Work Order ID 104706

Item Name: Crosstube Turning Detail

DART AEROSPACE LTD	Work Order:	104706
Description: Crosstube Assembly (412 High Aft)	Part Number:	D412-664-243
Inspection Dwg: D412-664-243 Rev: E		Page 1 of 2

DRAWING NO. D412-664-243	TITLE CROSSTUBE ASSEMBLY (412 HI AFT)	REV. E	DART AEROSPACE LTD ENGINEERING ORDER		D.E.O. NO. D412-664-243-E.1	SHEET NO. SHEET 1 OF 3	SCALE NTS
DRAWN 97	CHECKED A	MFG. APPR. A	APPROVED MP		DE APPR. MP		
DATE 12.08.21	DATE 12.08.30	DATE 12.08.30	DATE 12/8/30		DATE 12.08-30

**D412-664-243
ASSEMBLY DETAIL**

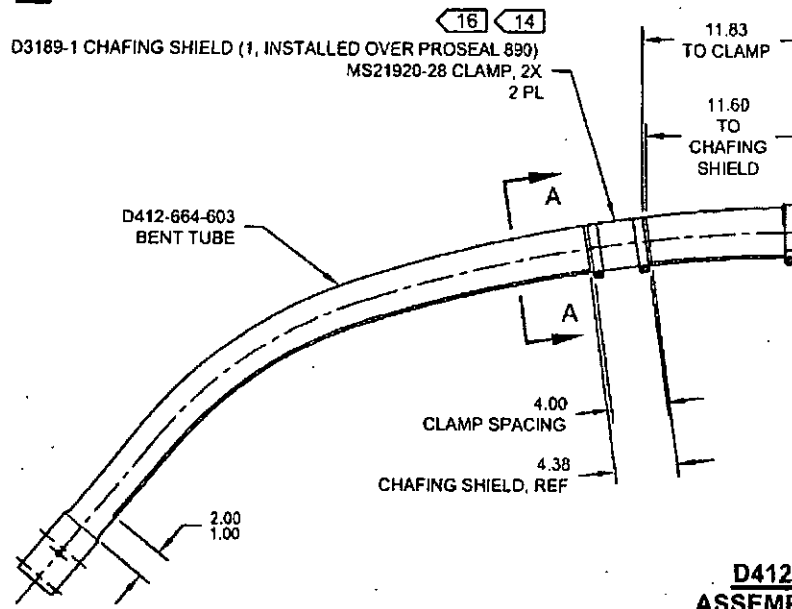
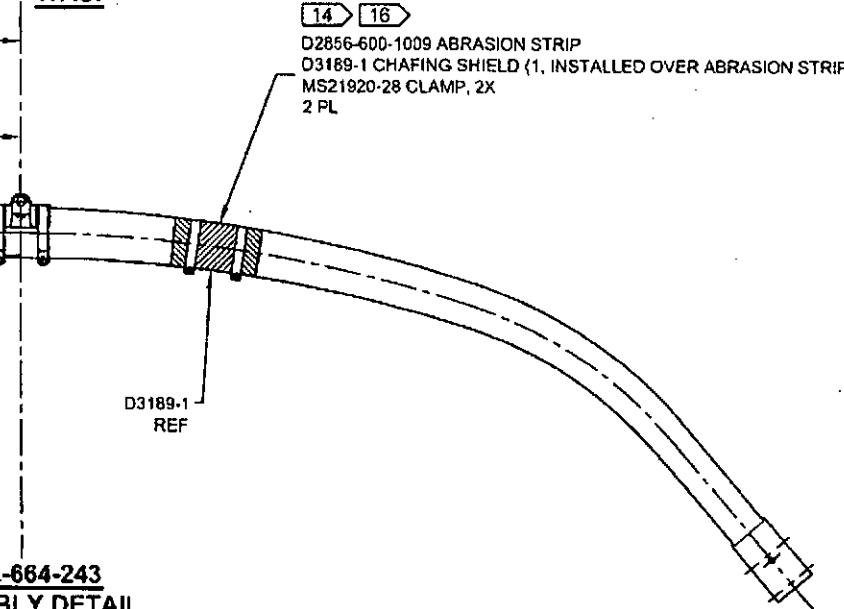
REMOVED ABRASION STRIP IN FAVOR OF A THIN LAYER OF PROSEAL 890. UPDATE INSTALLATION OF CHAFING SHIELDS AND REDUCE TORQUE TO 40-50 IN-LBS. THIS ENGINEERING ORDER SUPERCEDES DEO D412-664-243-E.1.

D3189-1 CHAFING SHIELD (1, INSTALLED OVER PROSEAL 890)
MS21920-28 CLAMP, 2X
2 PL

D2856-600-1009 ABRASION STRIP
D3189-1 CHAFING SHIELD (1, INSTALLED OVER ABRASION STRIP)
MS21920-28 CLAMP, 2X
2 PL

SECTION A-A
CHAFING SHIELD DETAIL
VIEW ROTATED, NOT TO SCALE

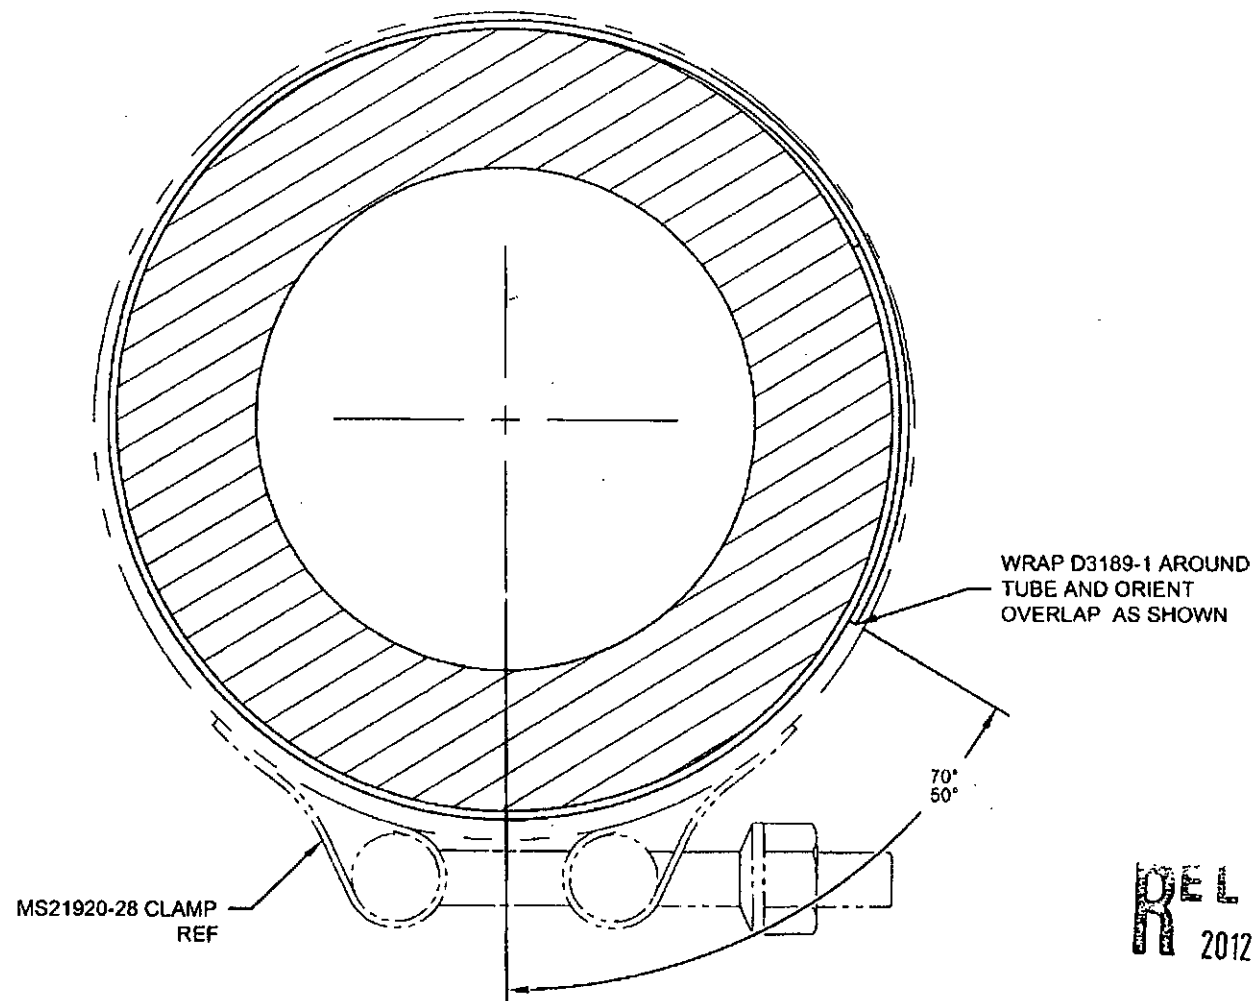
- 2) FINISH: CHEMICAL CONVERSION COAT PER DART QSI 005 4.1
PRIME INSIDE AND OUTSIDE PER DART QSI 005 4.2
MASK UNDERSIDE OF CROSSTUBE AS SHOWN (HATCHED AREA)
PAINT OUTSIDE PER DART QSI 005 4.2
AFTER PAINTING, APPLY CLEAR COAT ON HATCHED AREA
- 14) APPLY A THIN COAT OF PROSEAL 890 ON INSIDE CONCAVE SURFACE OF D3189-1 CHAFING SHIELD AND LET CURE PER MANUFACTURER'S INSTRUCTIONS. INSTALL PROSEALED D3189-1 CHAFING SHIELD ONTO CROSSTUBE BY APPLYING A THIN COAT OF PROSEAL 890 ONTO CROSSTUBE. BE SURE TO ELIMINATE ANY AIR GAPS.
- 16) TORQUE CLAMPS ON D2896-1 SUPPORT 80 TO 100 IN-LB. **TORQUE CLAMPS ON D3189-1 CHAFING SHIELD 40 TO 50 IN-LB.** ENSURE AT LEAST 1.5 THREADS SHOWING IN SAFETY AND THAT NUT HAS NOT BOTTOMED-OUT AFTER TORQUING.
